HIROSE ELECTRIC CO., LTD.
2-6-3 Nakagawa Chuoh, Tsuzuki-ku, Yokohama, JAPAN**Product Specification Change for HIF3, B, C, M, and FX2B Series**

Supplementary Documentation for Product Changes in HIF3, B, C, M and FX2B Series

PCN No.	PCN2025-06
Title	Product Specification Change for HIF3, B, C, M, and FX2B Series

Change 4

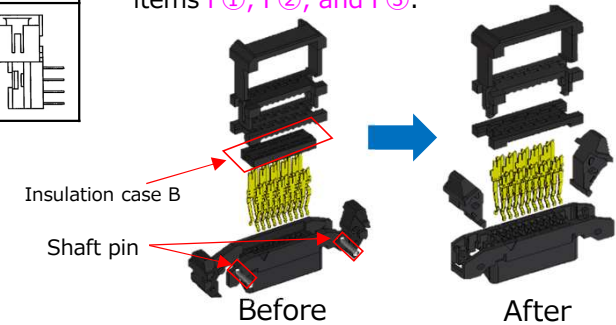
Change the number of parts used for items F①, F②, and F③.

Change 6

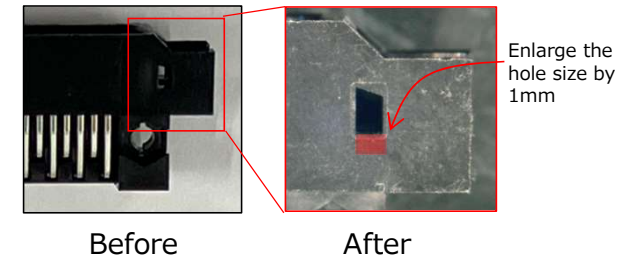
Change the hole size on the side of the insulation case for item F⑤.

Change 2

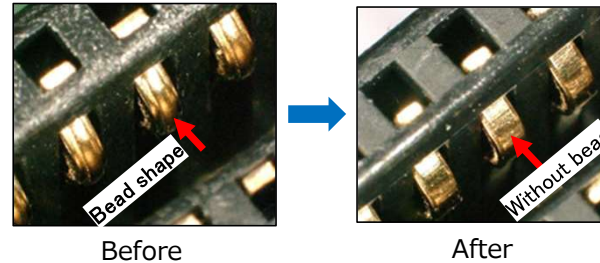
Change the terminal material of items F①, F②, and F③ (within copper alloy types) and modify the contact area shapes.

Change 3

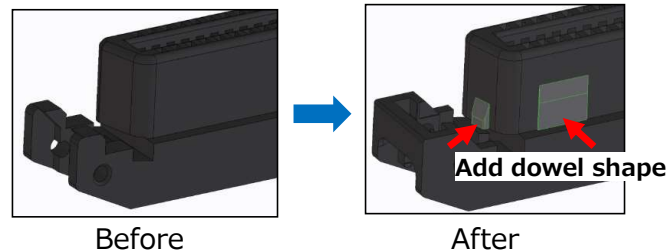
Change the side shapes of the insulation cases for items F①, F②, and F③.

Change 1

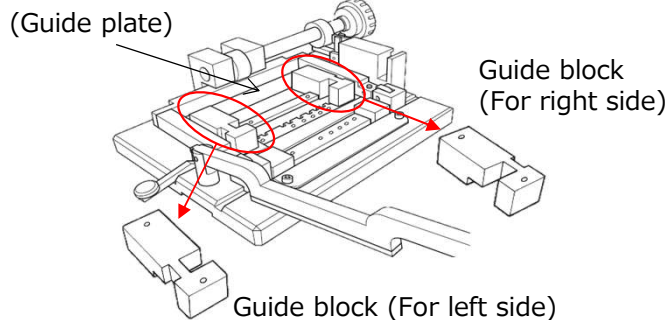
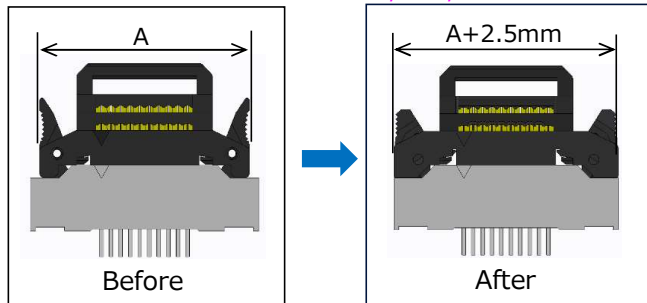
Change the lock shapes and external dimensions for items F①, F②, and F③.

It is necessary to purchase an additional set of guide blocks (left and right).

Part number for the left guide block: FX2BR-GPA(71)
Part number for the right guide block: FX2BR-GPA(72)
